MEMORANDUM

SUBJECT: **Final Report** for ZC Case No. 16-11, Consolidated Planned Unit Development (PUD) and PUD Related Map Amendment from R-4 and C-2-A to R-5-B and C-2-B for Square 2890, part of Lot 849 (Bruce Monroe)

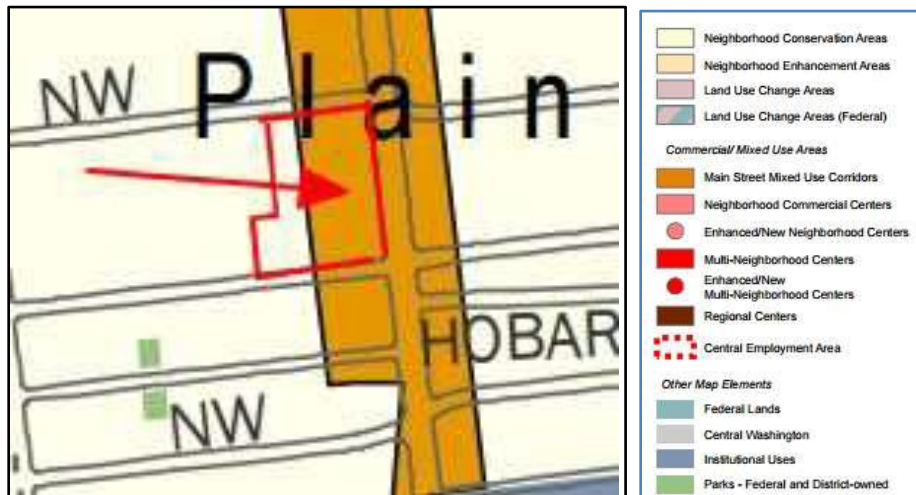
- g. **Parking:** Regulations require parking to be on the same lot as the building it serves. The applicant proposes that the parking for the townhouses and semi-detached units not be located on the lots with the houses, but on a separate lot to be dedicated as a private street

serving those dwellings. As no alley is proposed to run along the rear of the townhouses, which would bring vehicular traffic closer to the rear yards of the existing dwellings on Columbia Road, access to off-street parking on the individual townhouse lots is not possible. Providing parking on the private street to the front of the townhouses would not be out of character for the neighborhood as not all of the existing row houses have on-site parking within their rear yards and on-street parking is common. All of the parking spaces serving the townhouses are proposed as compact spaces, and the applicant needs to request flexibility from Sec. 2115, Size of Parking Spaces.
